Ms. Kym Dicome Urban Design & Development Division P.O. Box 1293 Albuquerque, NM 87103

### RE: SITE DEVELOPMENT PLAN FOR BUILDING PERMIT UTILITY TRAILER SALES 18EPC-40004- PROJECT# 1008585

### **OFFICIAL NOTIFICATION OF DECISION**

Utility Trailer Sales, Inc 9200 Brighton Road Henderson, CO 80640 Project# 1008585 18EPC-40004 Site Development Plan for Building Permit

DRAWN BY LA
DATE
03/20/2018
2017041_MUE
SHEET #
C3
<b>ЈОВ #</b> 2017041

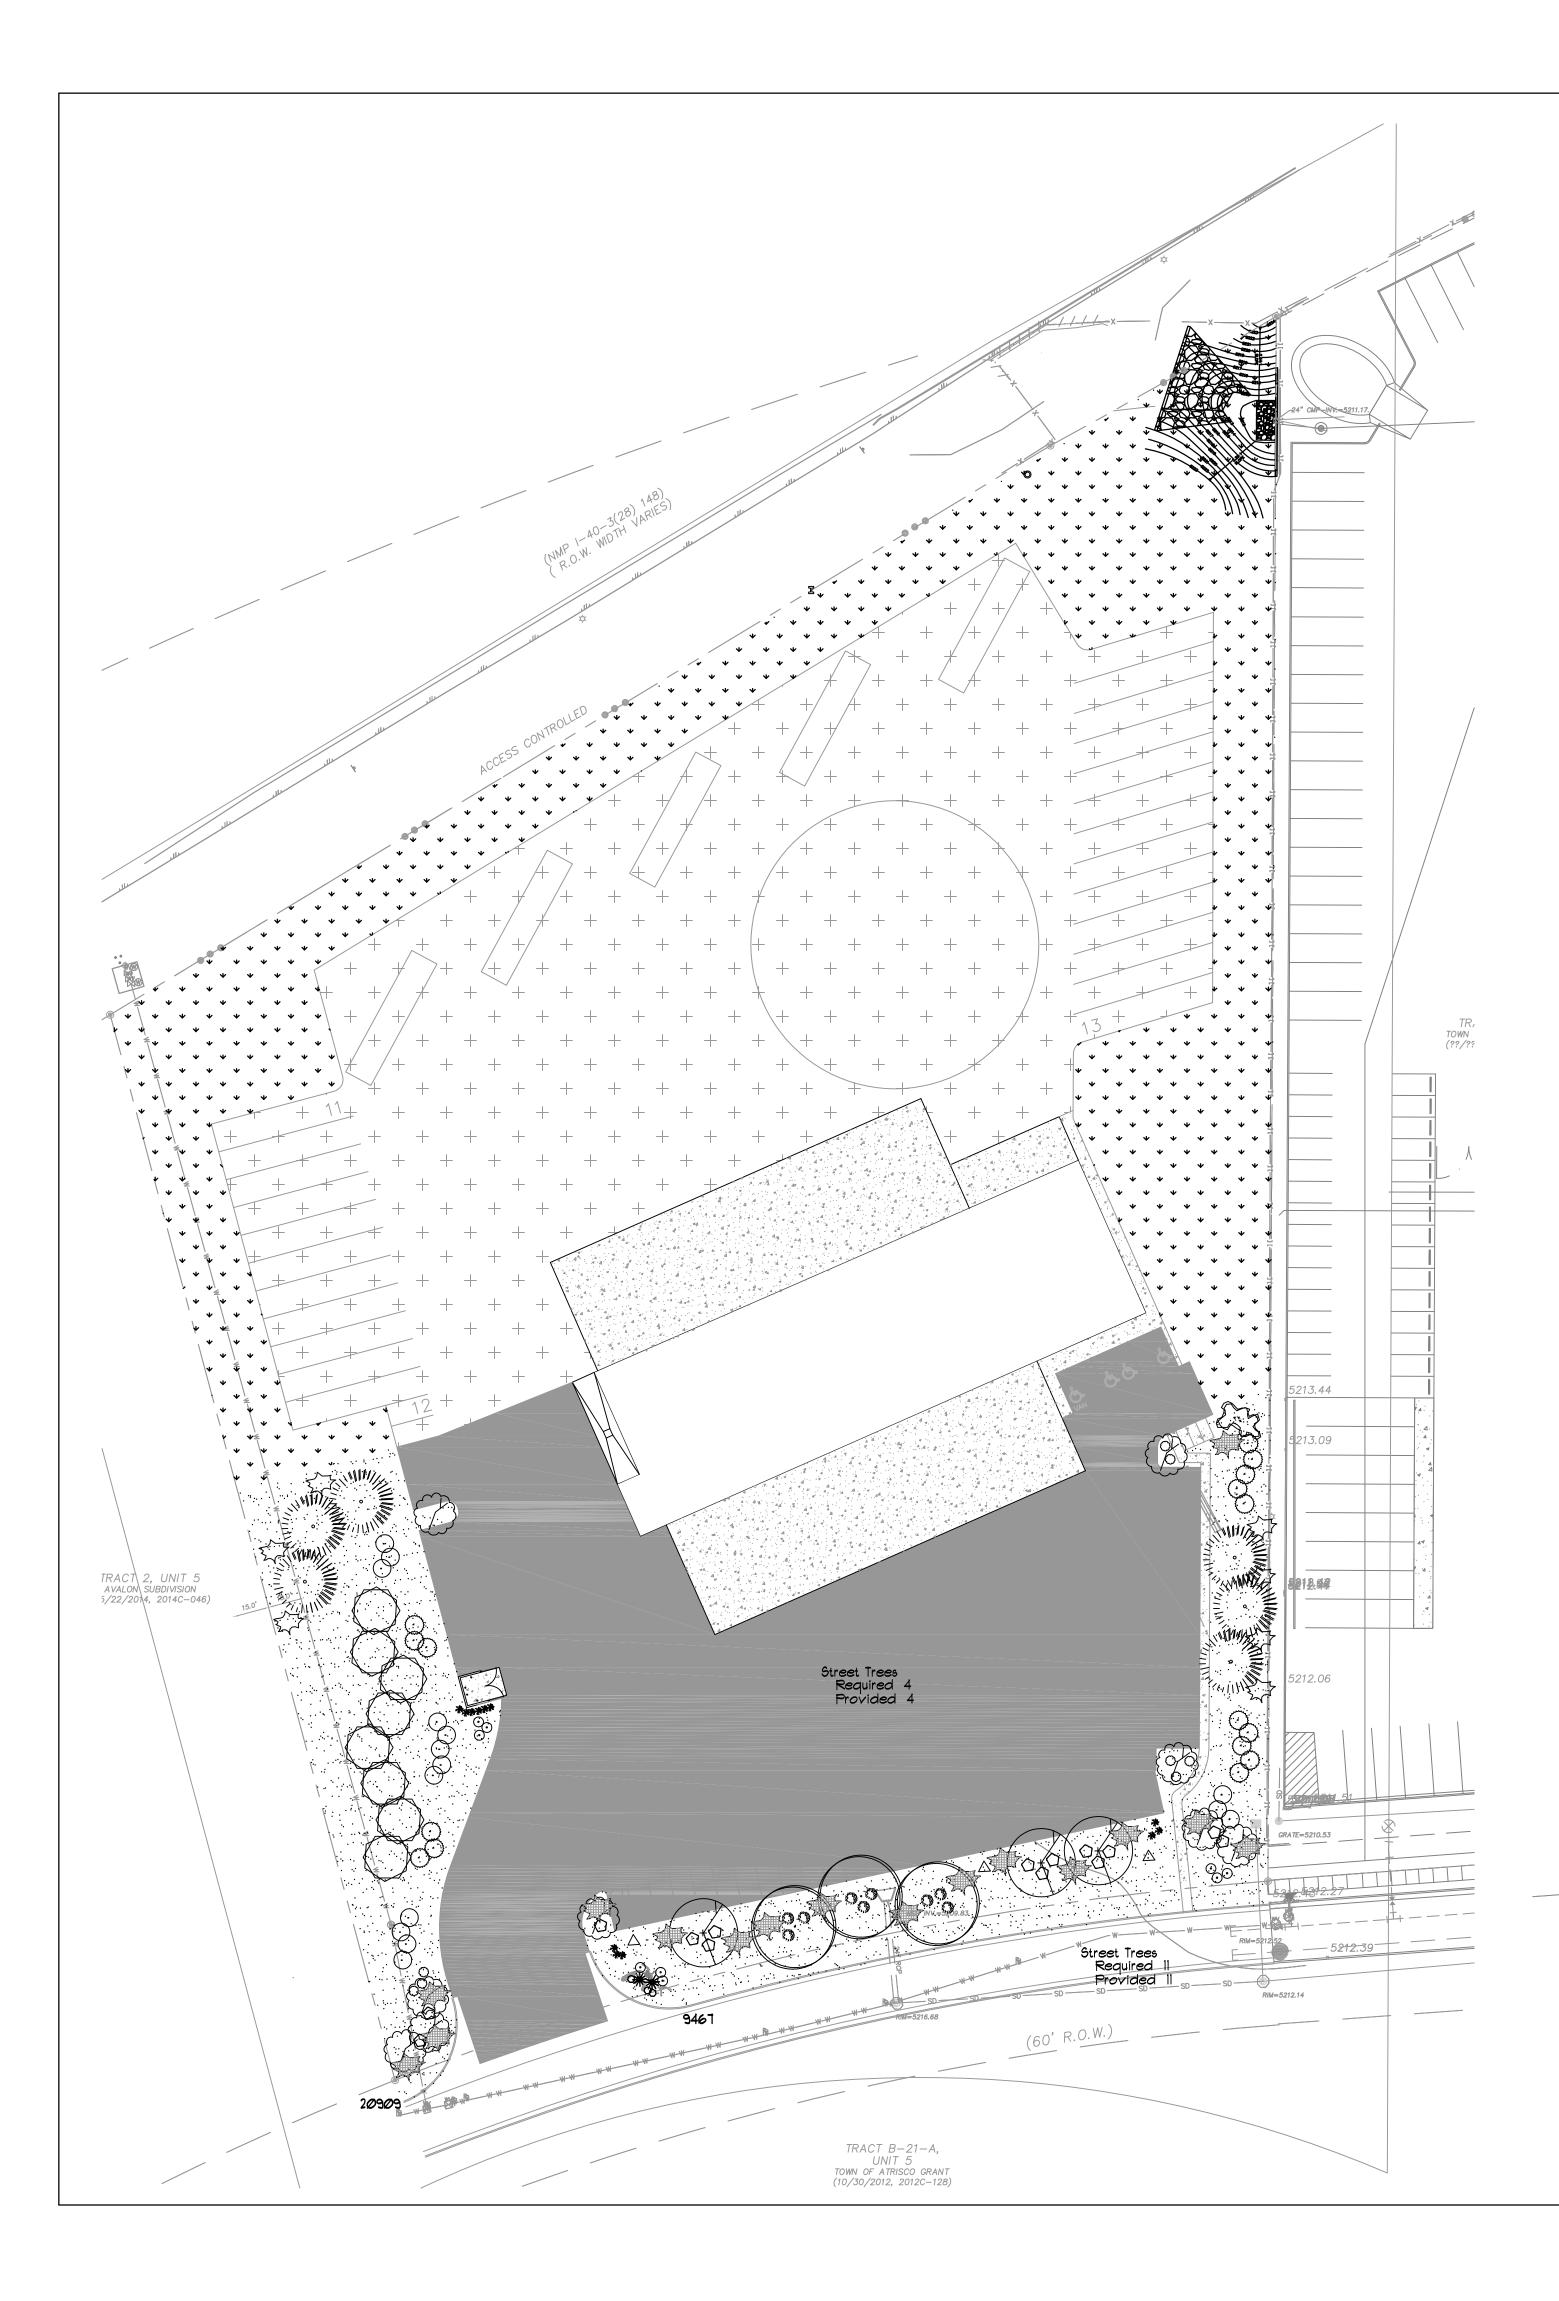
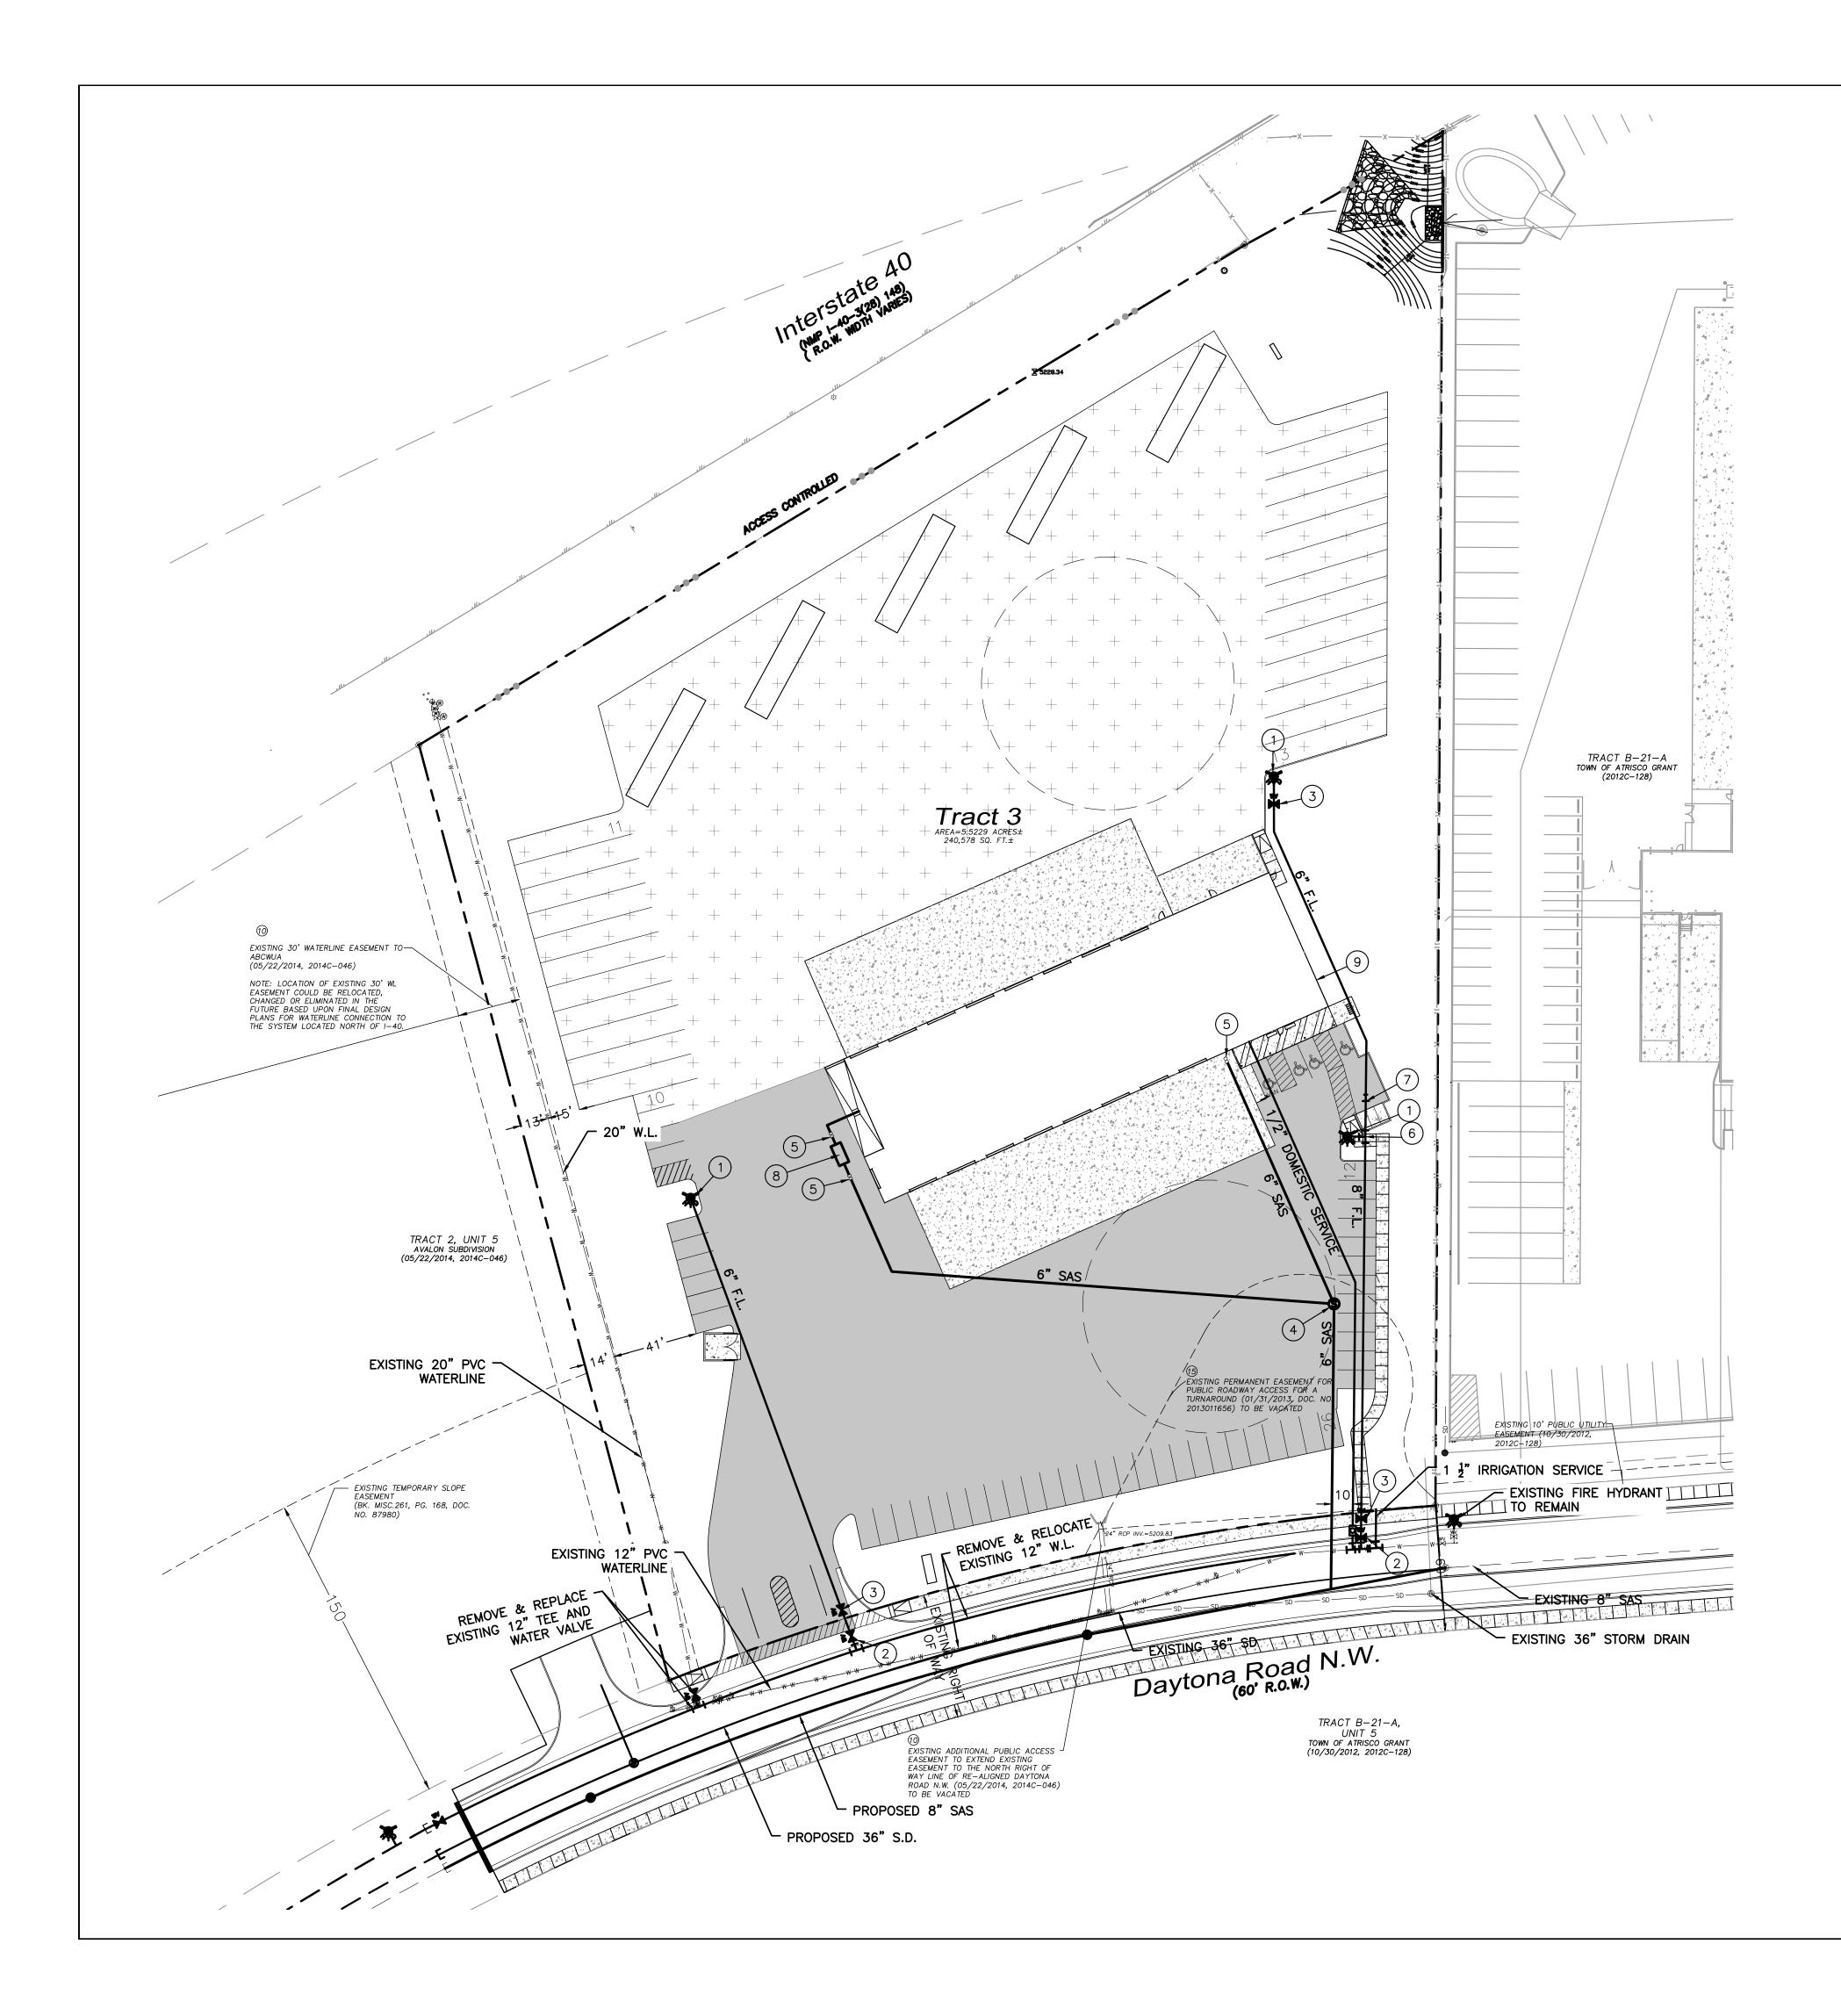
• The indicated fire line shows two hydrants. Please note that these hydrants are to be considered private and shall be painted safety orange.

• The proposed fire line connection to the 20 PVC distribution main along the west border of the site is not a permissible connection. If this hydrant is a required hydrant consider an additional connection Daytona Rd.

Response: The indicated fire hydrants are noted as private and a note was added to paint them safety orange.

Response: The fire line connection was revised to show it coming off the 12" waterline in Daytona Road.
